Access Compliance Report

Public Rights-of-Way

| Intersection ID: 31403 | Main Street: BITTERROOT_CT | Cross Street: BRAWER_FARM_DR | Location: S |
| ADA ID: E40A4DF14C1C | Ramp Type: PerpDiag | Initial Pass/Fail: Fail | Overall Compliance: No |

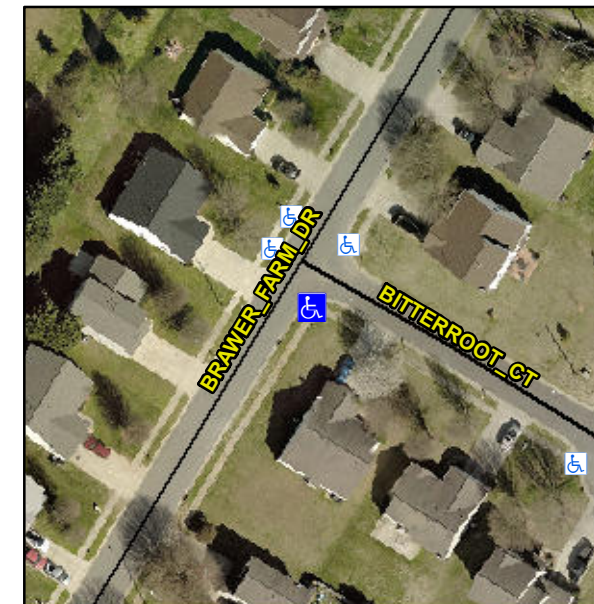
R304.2.2, R304.5.3

| Compliance | Description | Data | Compliance | Description | Data |
|------------|-----------------------|-------|------------|-----------------------------|-------|
| N/A | Ramp Length (in) | 45.0 | No | Ramp Slope (%) | 8.8 |
| Yes | Ramp Width (in) | 49.0 | No | Ramp XSlope (%) | 5.3 |

Remove & Replace Curb Ramp With Two New Directional Ramps or Equivalent.
